MARTIN
COAL GASIFICATION
COMBINED CYCLE
PROJECT

SITE CERTIFICATION APPLICATION
SUFFICIENCY RESPONSES

FLORIDA POWER & LIGHT COMPANY'S
NOTICE OF FILING RESPONSES TO
SUFFICIENCY QUESTIONS OF
THE DEPARTMENT OF ENVIRONMENTAL REGULATION
AND THE
SOUTH FLORIDA WATER MANAGEMENT DISTRICT

Re: FPL Martin Coal Gasification/Combined Cycle Project
Power Plant Site Certification Application PA 89-27
DOAH Case No. 90-259

Figure 1 FLUE GAS EQUILIBRIUM COMPOSITIONS - GAS NO. 2

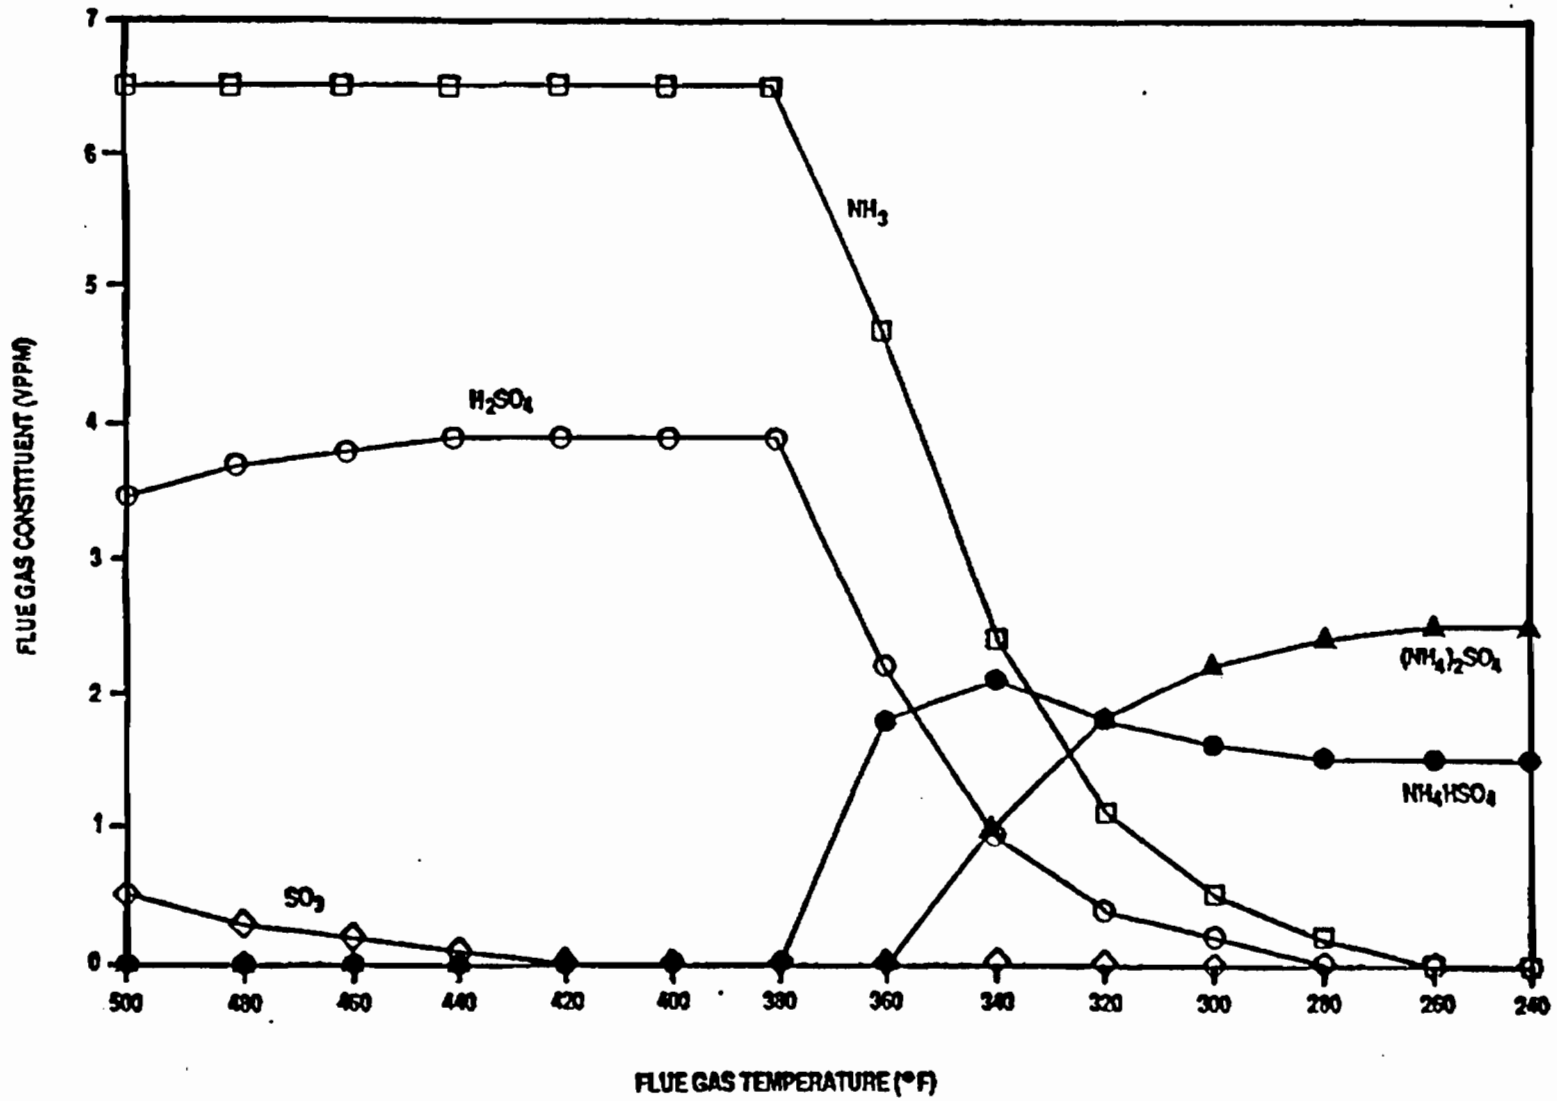
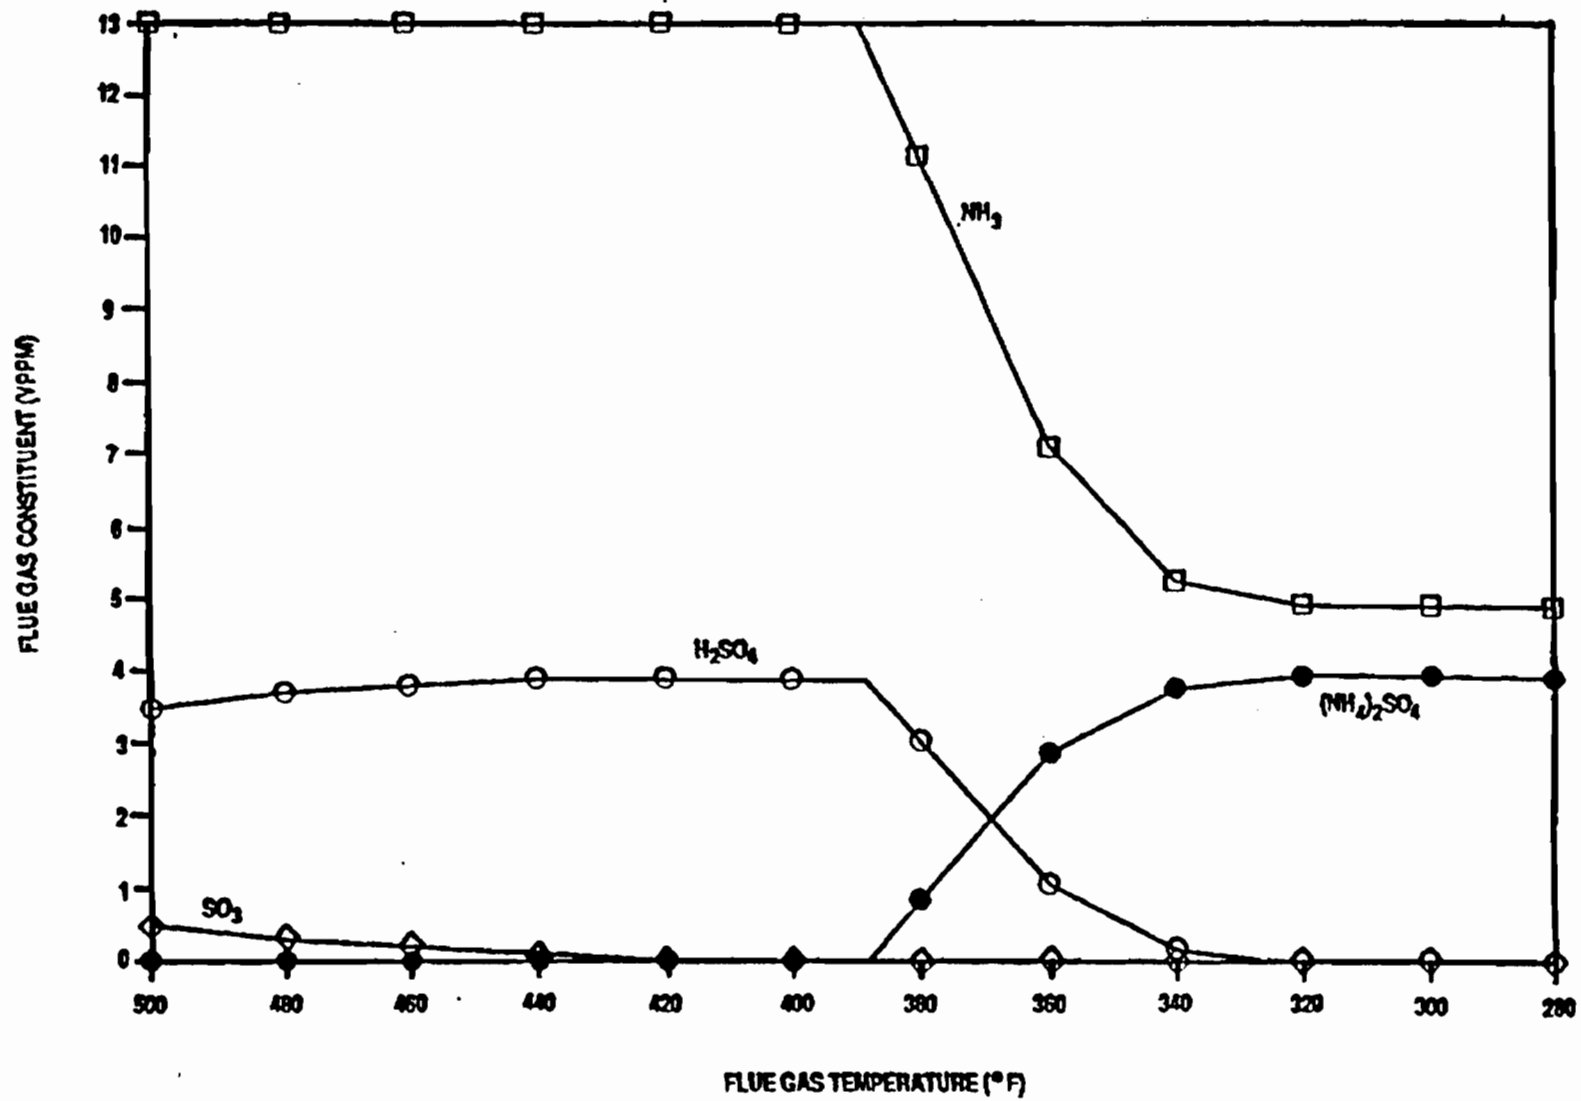
"Provide response to EPA Region IV's comments regarding BACT (copy of letter attached)."

The formation of ammonium bisulfate and sulfate downstream of the SCR reactor is a complex function of gas composition and temperature. This problem was evaluated in a study recently conducted by Exxon for General Electric Company. The results of Exxon's calculations are shown in Figures 1 and 2. Both calculations used an exhaust gas composition based on firing 0.2 percent sulfur distillate oil. In Figure 1, the unreacted ammonia leaving the SCR was assumed to be 6.5 ppm, and in Figure 2 it was 12 ppm. In Figure 1, ammonium bisulfate begins to form at temperatures below 380° , and below 360° , ammonium sulfate forms as well. By the time the gas reaches 260° , all of the sulfur present as either SO_3 or as H_2SO_4 has reacted, consuming all of the excess ammonia as well. Figure 2 shows that at the higher level of unreacted ammonia, only ammonium sulfate forms but excess ammonia in the stack gases would be 5 ppm.

The Exxon study was intended to illustrate that the formation of ammonium bisulfate is a complex function of the gas chemistry and temperature. These types of calculations are necessary but impractical on a real-time basis, and thus control of ammonium bisulfate over the full range of the Martin Project operating conditions is not practical.

The only effective means for limiting the formation of ammonium bisulfate is to limit the sulfur content of fuel. Pipeline quality natural gas has negligible sulfur content. However, the

lowest sulfur content of the distillate oil available to the Martin Project is not low enough to prevent formation of ammonium bisulfate.

FIRST STAGE DRAINAGE PLAN

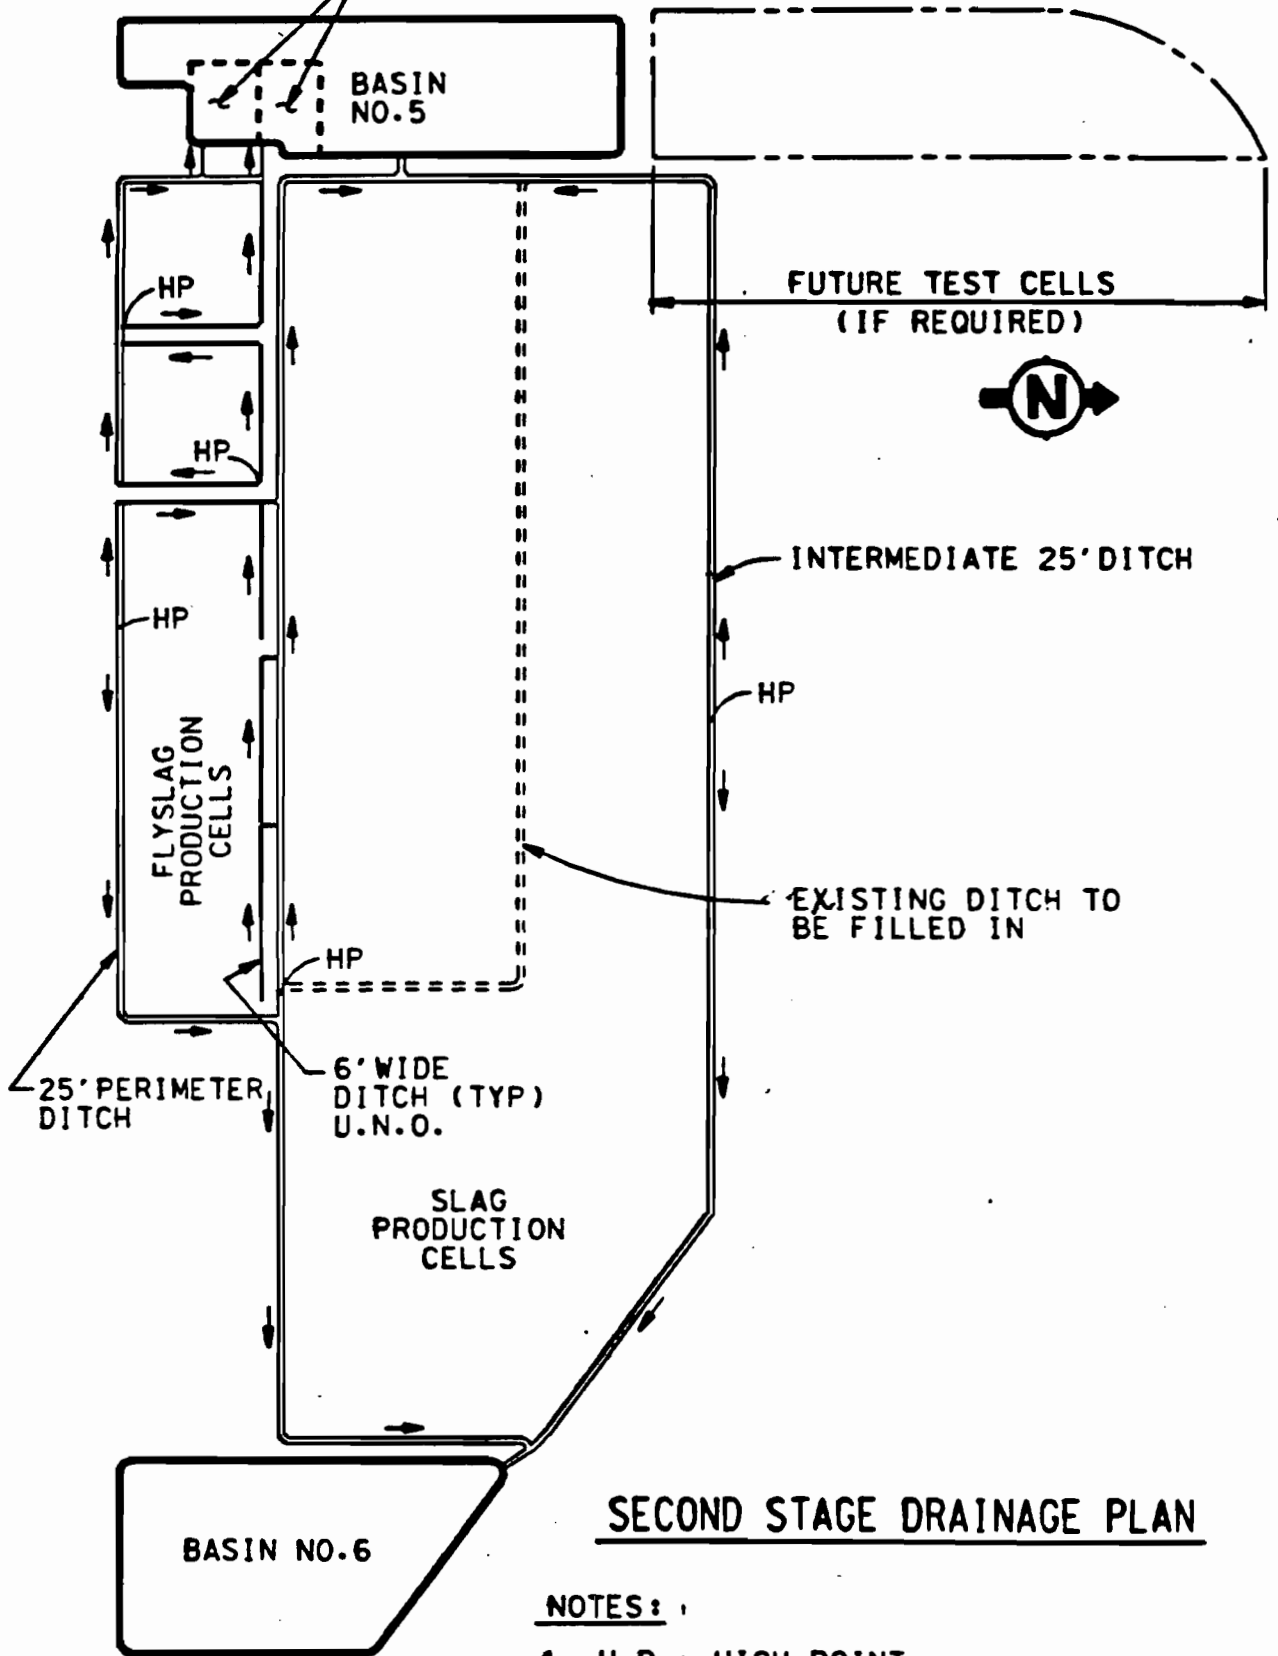
46. The solid waste area test cell program, so far as it was described on pgs. 3.7.1-10 through 15, is insufficient as proposed. To merely collect for analysis, "leachate and runoff resulting from rainfall", would not substitute for a ground water leachate study employing unlimited test cells and monitoring wells, primarily because of the great dilution with rainwater materials. Please provide, under 6)b) above, details of such a test-cell/ground water leachate study, or else provide documentation that the entire solid waste storage area would be lined and underdrained. Suggest that you also contact Solid Waste personnel for appropriate rule applicabilities.

During the first stage, runoff detention Basin No. 5, and the perimeter ditches around the test cells and the production cells, will be constructed as shown on attached Exhibit DER-46A "First Stage Drainage Plan". The runoff from each test cell will be conveyed separately into

individual compartments in the collection basin. The runoff from the production cells will be directly conveyed into the collection basin. The runoff from the undisturbed area will continue its existing course of flow and discharge into the existing eastern perimeter ditch. The temporary perimeter road and runoff ditches around Stage I test cells and production cells will separate the runoff water of the developed area from the undisturbed area.

FIGURE DER-56 DRAINAGE AREAS

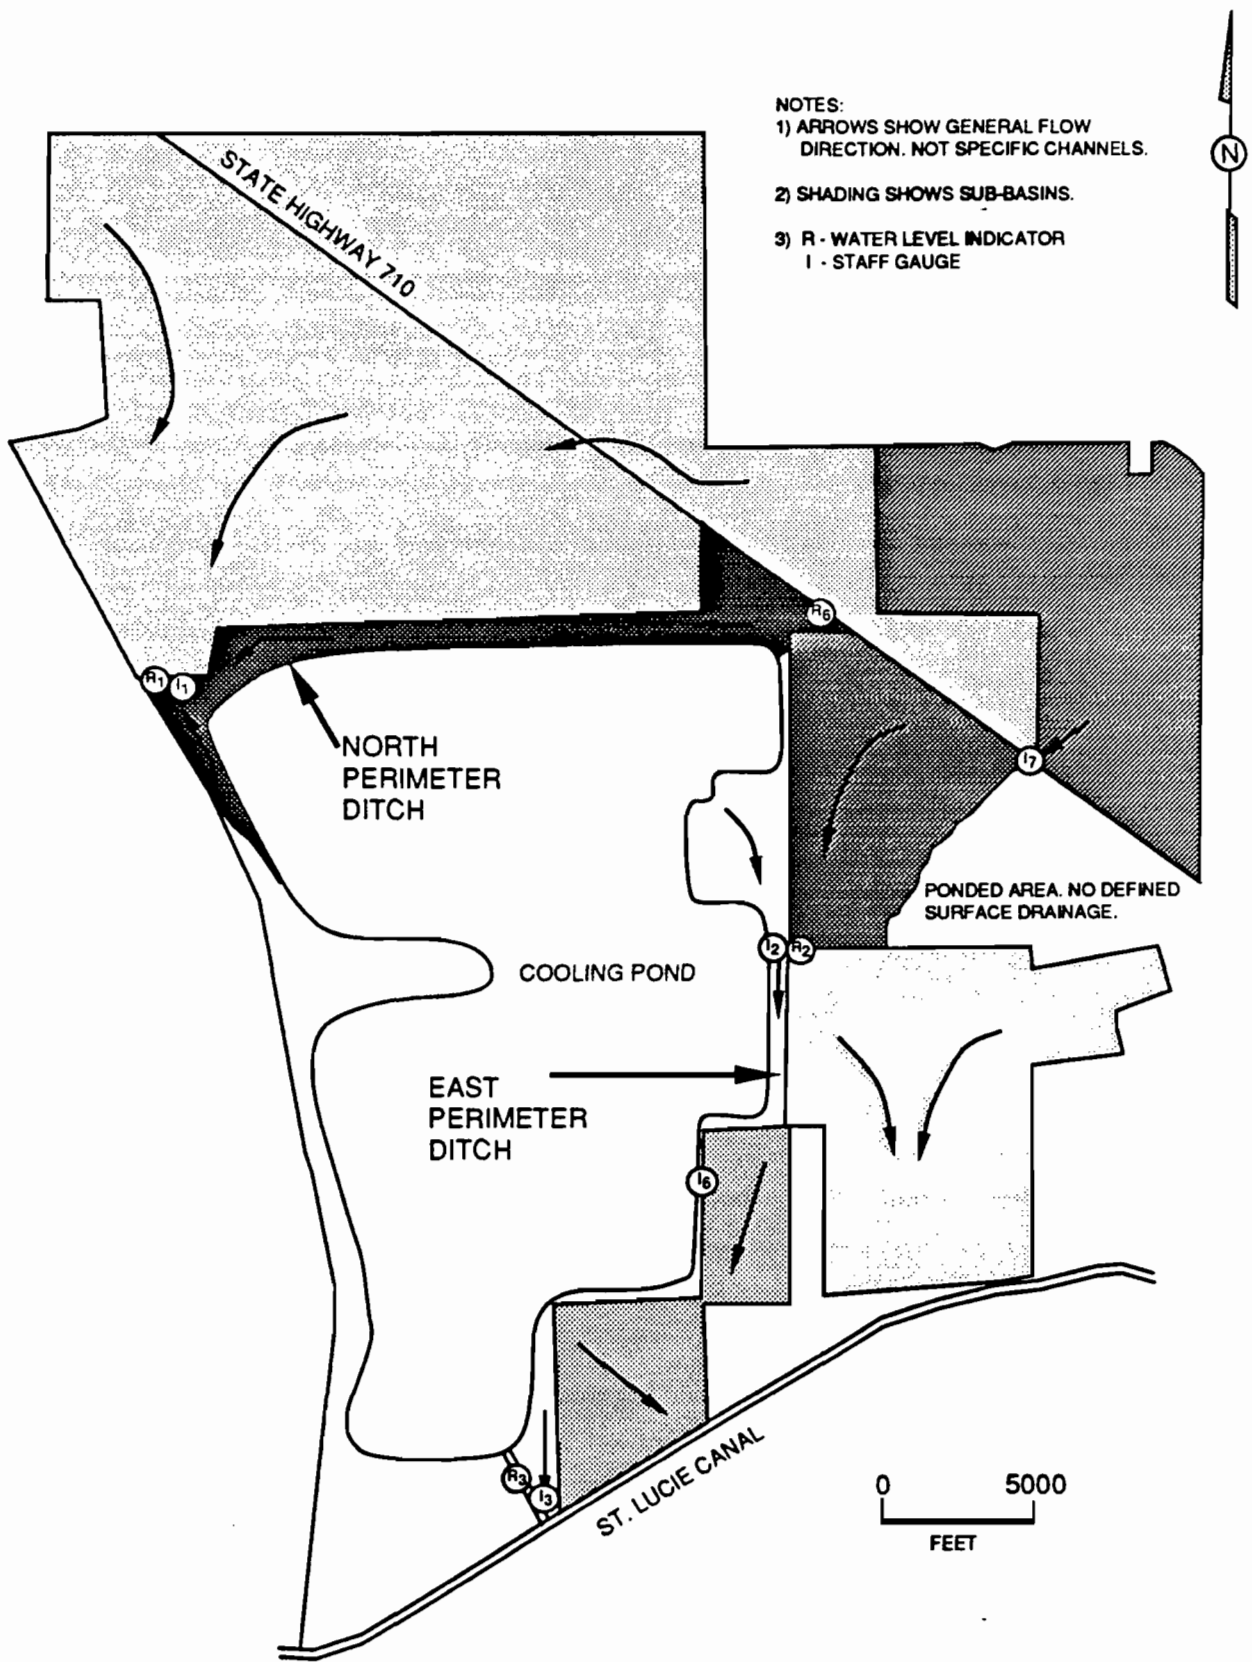
"The locations of station I₁-7 and R₁-6 should be identified in Figure 2.3.4-38."

The locations of the stations in question have been added to attached Exhibit DER-56. Relevant stations are as follows:

I₄ - in EDD just downstream of confluence with ditch containing I₂ and R₂

I₃, R₃ - in EDD near its control structure at intake/discharge canal.

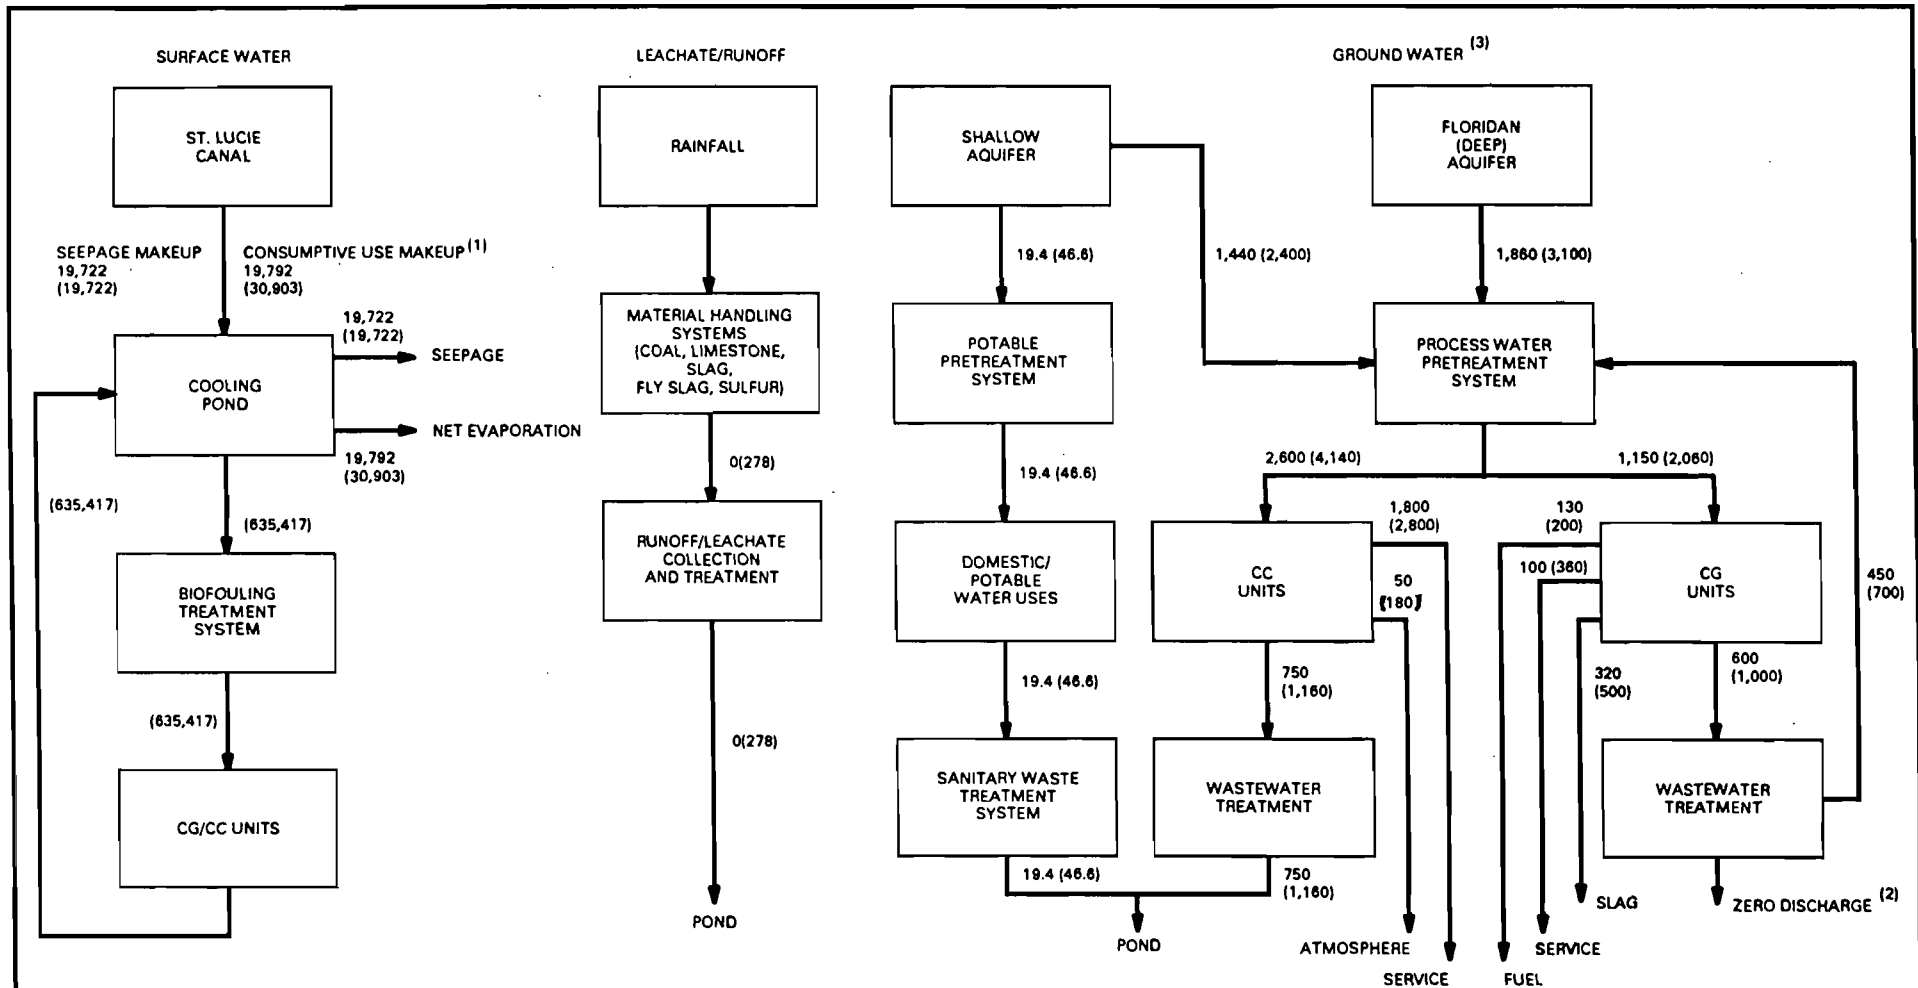
"Projected use inputs/outputs (Figure 3.5.0-1) do not balance for the CC units."

The inputs/outputs for the CC Units shown in SCA Figure 3.5.0-1 will balance if the average and peak flow discharges to the atmosphere are switched as provided in the attached Exhibit DER-57.
